17224 COPPER VALLEY COURT

GRADING, EROSION, & SEDIMENT CONTROL PLAN

PCD FILE NO. VR2512

17224 COPPER VALLEY COURT
GRADING, EROSION, & SEDIMENT CONTROL PLAN

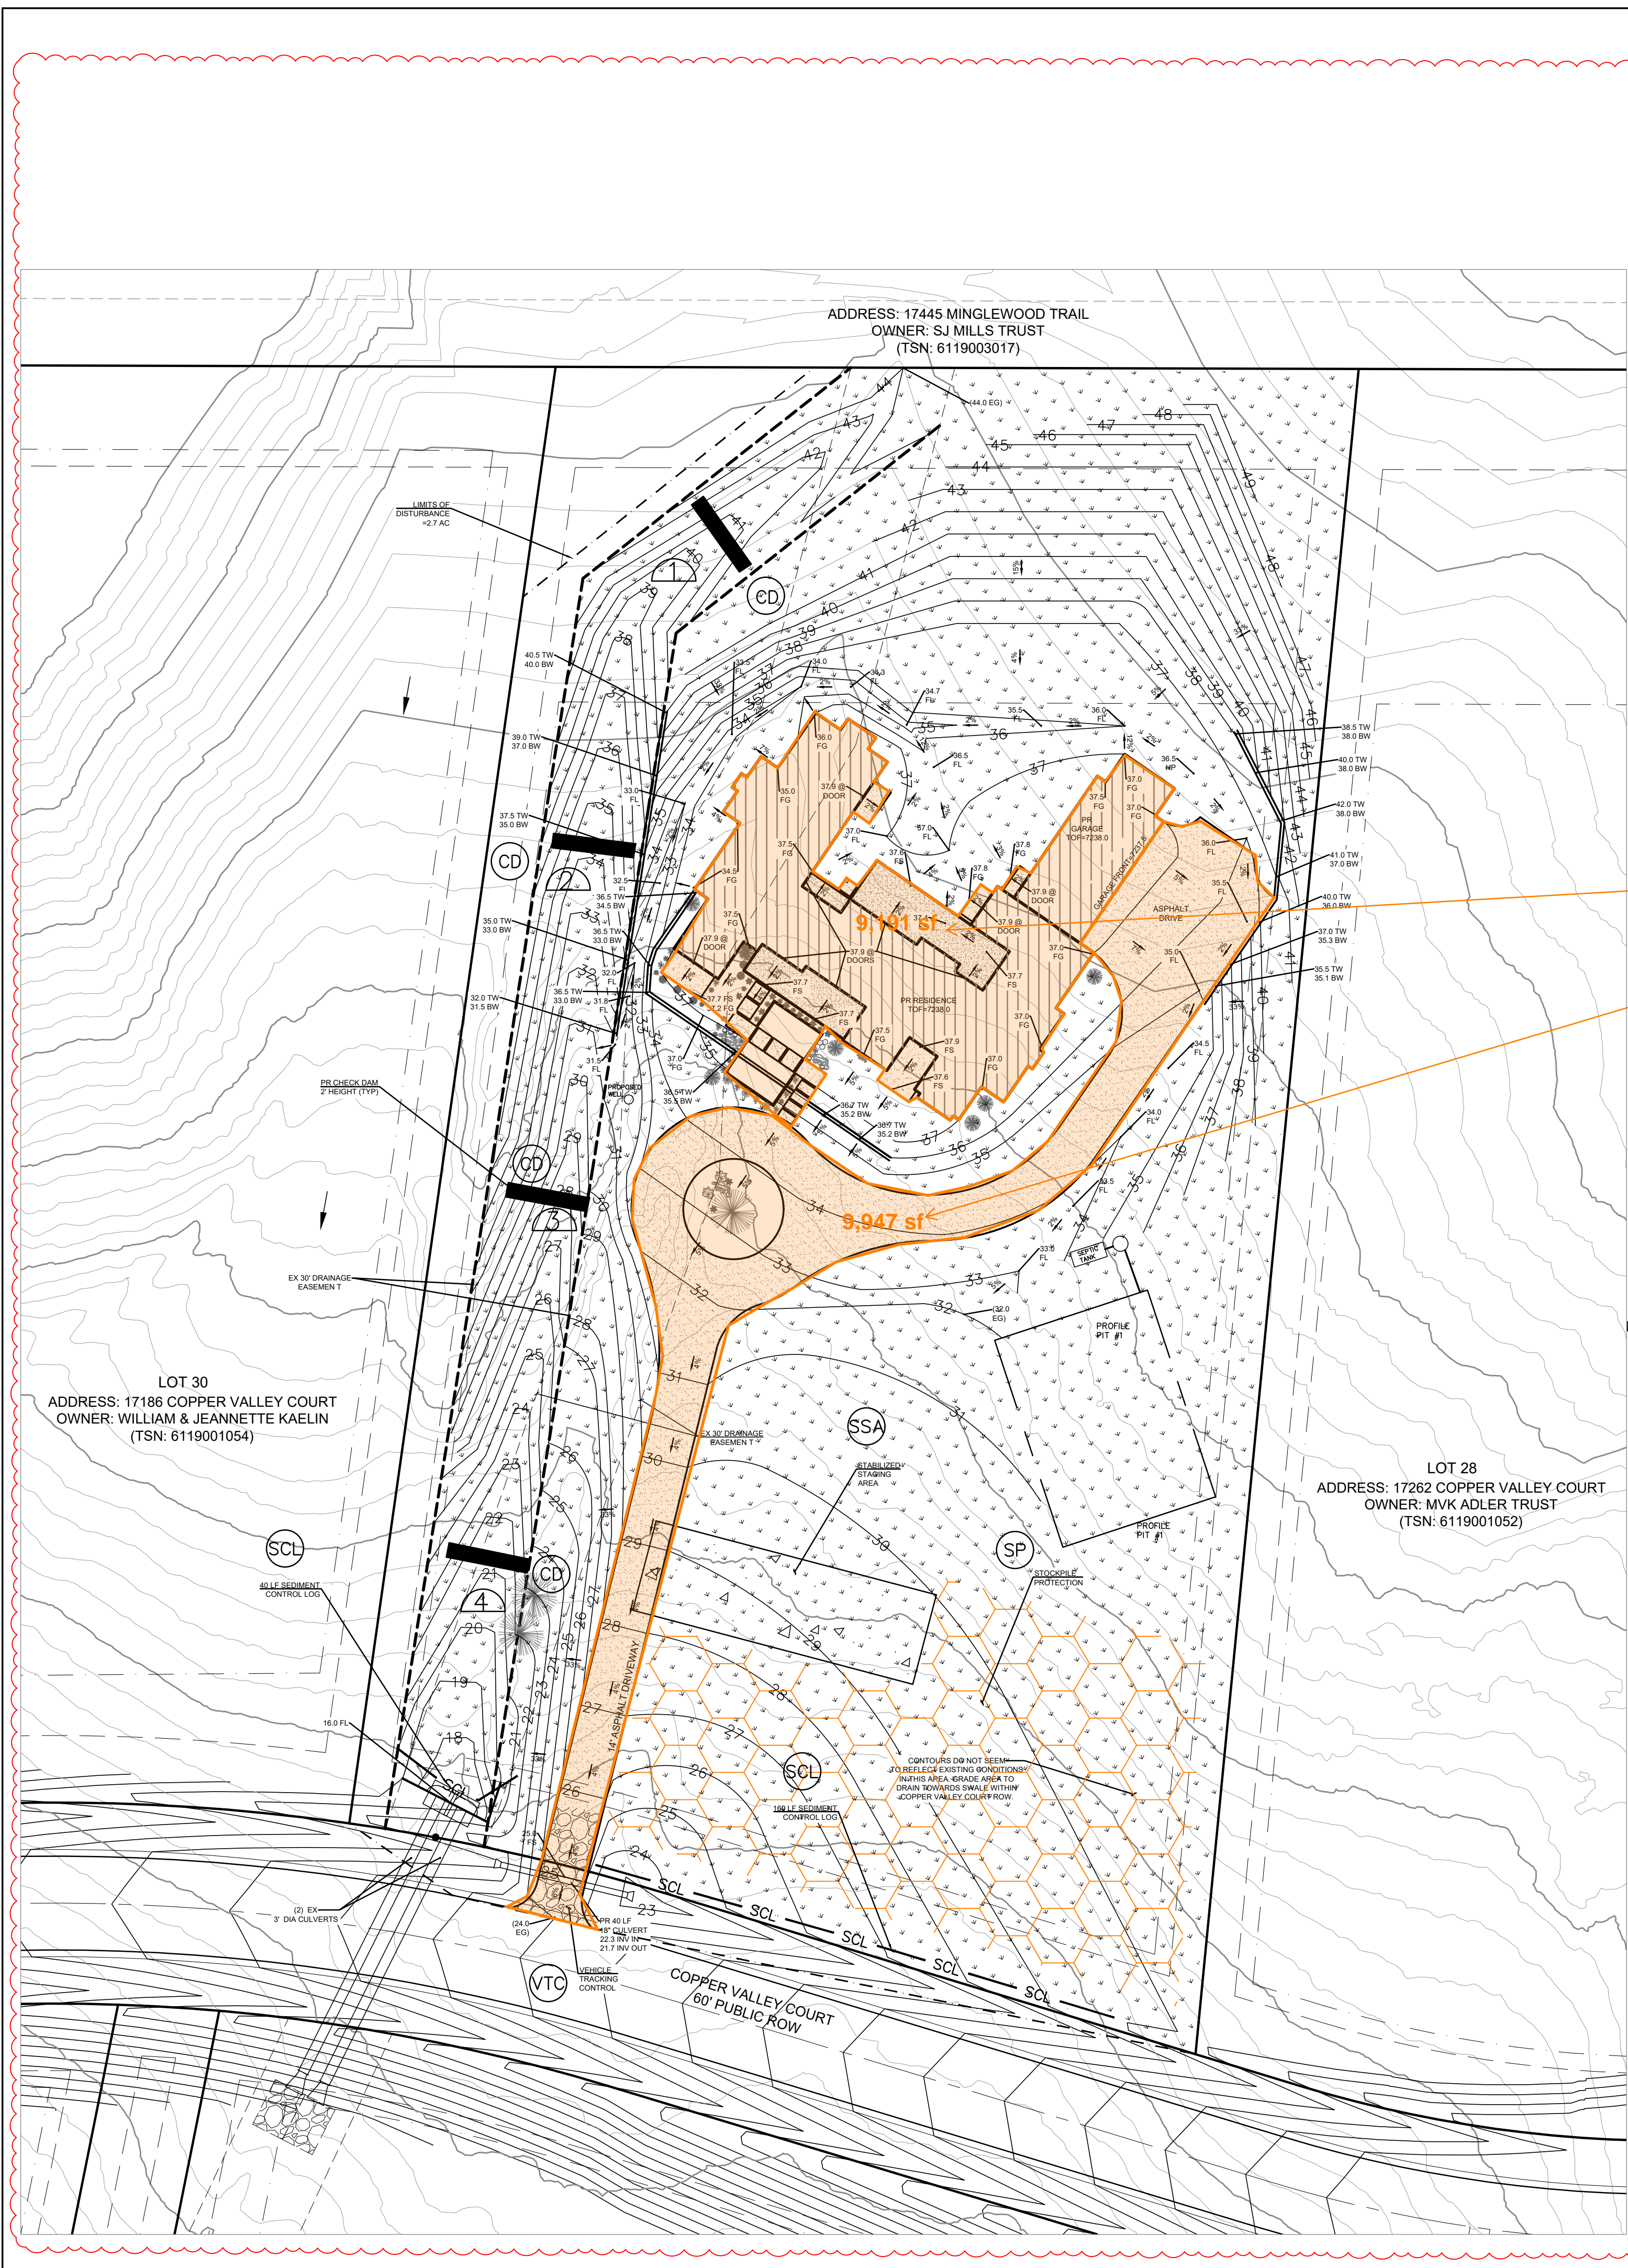
By my rough estimate, the impervious area is 0.44ac which for this 2.68ac lot is 16.4% impervious. The design of the Grandwood Ranch development utilized the Large Lot PCM exclusion which allows the exclusion of the lots from needing water quality treatment as long as they have <10% imperviousness. For lots that will have >10% but <20% imperviousness, the applicant will need to submit a site-specific study that shows that the soil and vegetation conditions are suitable for infiltration/filtration of the Water Quality Capture Volume (WQCV). This generally involves preparing Runoff Reduction calculations and a short report to discuss the site, calculations, and a drainage map. Attached is a go-by and an email with more instructions:
